**THE
NATIONAL
BOARD**
OF BOILER AND
PRESSURE VESSEL
INSPECTORS

**NATIONAL BOARD
SUBGROUP
PRESSURE RELIEF DEVICES**

MINUTES

Meeting of January 15, 2019
San Antonio, TX

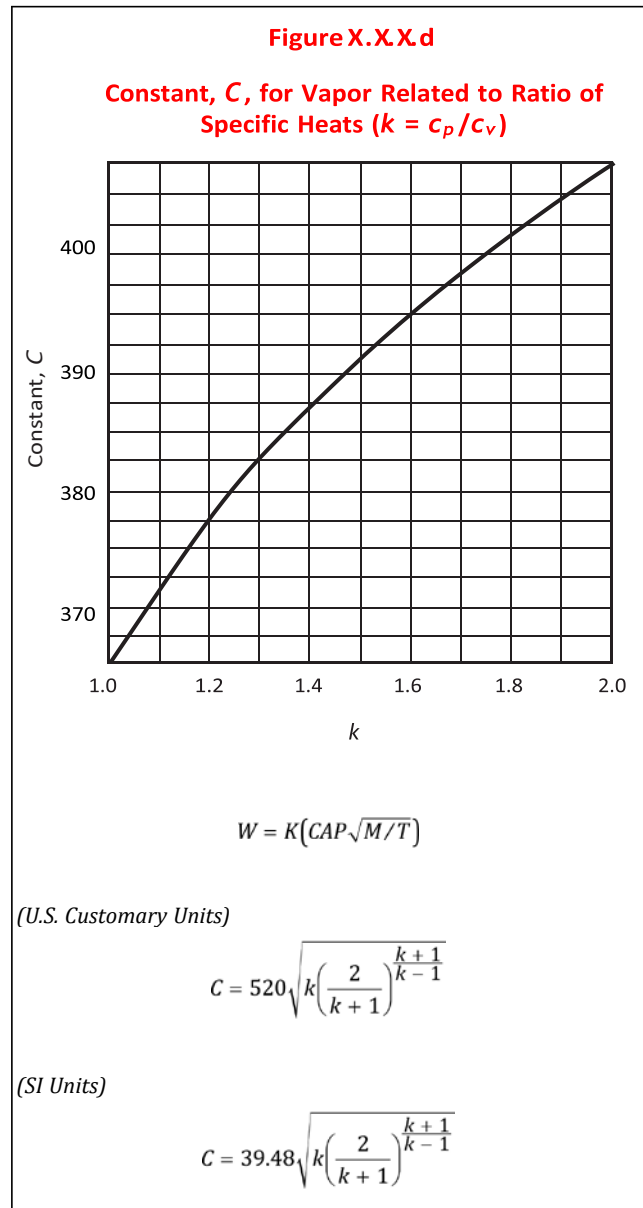
C = Constant for vapor that is a function of Specific Heats $k=c_p/c_v$ (See Figure x.x.x.d).
Note: Where k is not known, $k=1.001$
